I wish to make a submission under sections 53 and 54 of the *Fast-track Approvals Act 2024* regarding the proposed development works affecting Alwyn Avenue.

My primary concerns relate to the proposed busway and cycleway crossover adjacent to Alwyn Avenue, along with the unnecessary removal of the existing earth bund that currently provides effective sound and visual mitigation from State Highway 16.

NWRT-00-00-EN-DRW-1106a (NWRT_Part-6_1_Indicative-Design_West.pdf)

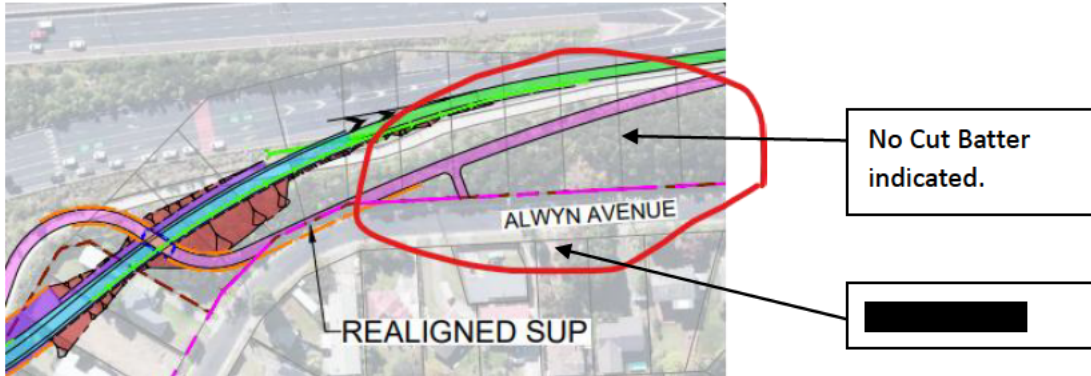
I also submit that the existing route of the cycleway should remain in its current alignment, rather than being diverted in a manner that requires the removal of established bund material, flora, and

fauna. The map NWRT-00-00-EN-DRW-1106a does not fully disclose the required Cut Batter with the realignment.

Image 1.01a

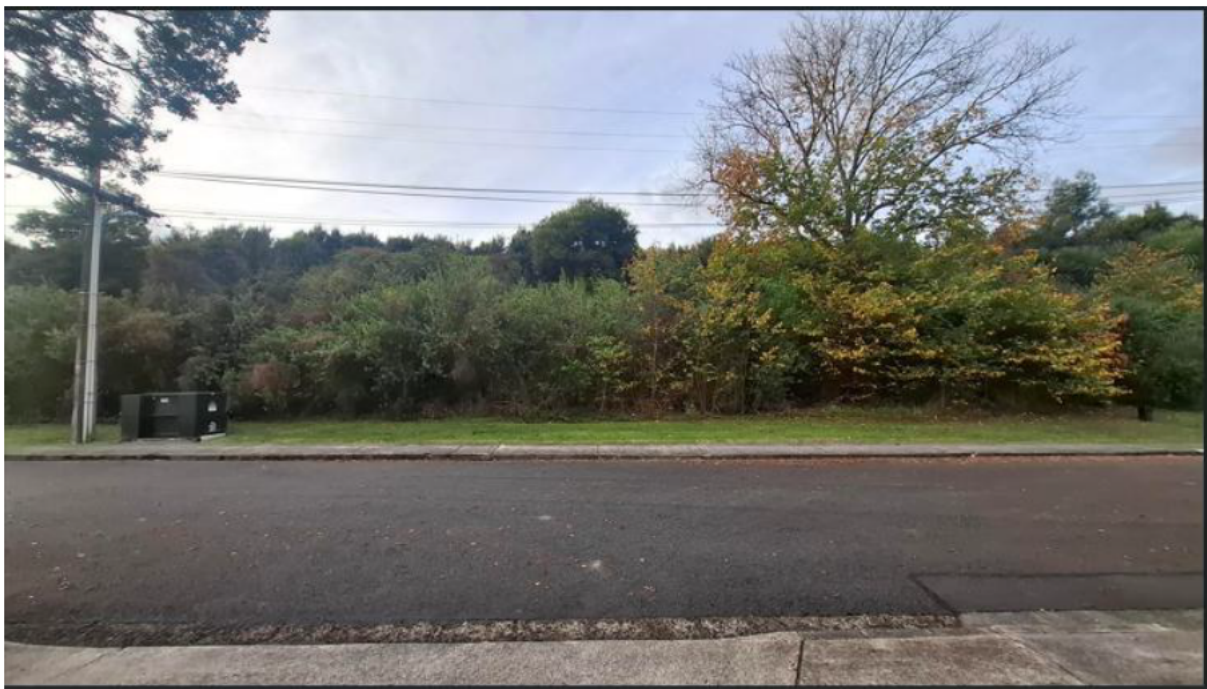
The bund is at a significant height at this point and a Cut would be required to make manageable for cyclists and pedestrians. Image 1.01a and 1.01b demonstrate the height. Note power pole for reference. Images a and b are taken outside [REDACTED]

NWRT-00-00-EN-DRW-1106a (NWRT_Part-6_1_Indicative-Design_West.pdf)

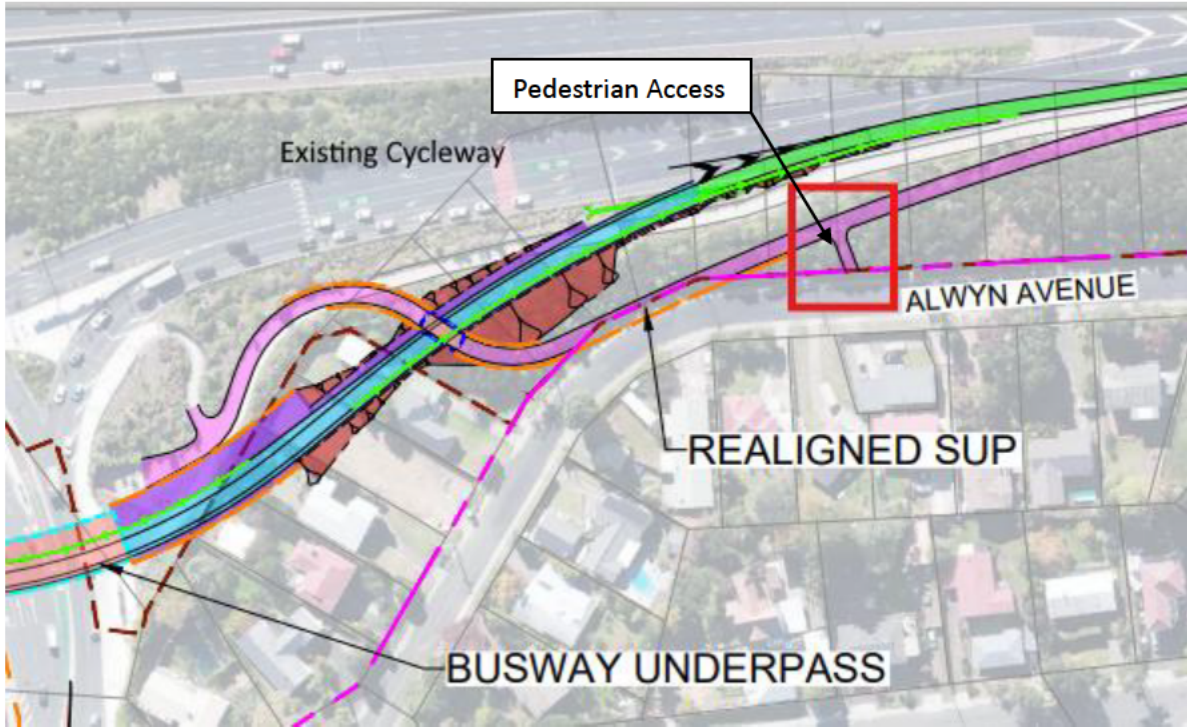
I also oppose the proposed pedestrian access directly onto Alwyn Avenue.

In my view, this access is not required for residents and will largely function as access associated with nearby Te Atatū Ōrangihina station. Alwyn Avenue contains two awkward and partially blind corners, Images 1.02.a1, 1.02a2 and 1.02b and any increase in pedestrian movements, vehicle parking, or non-resident traffic will significantly increase safety risks and the likelihood of accidents.
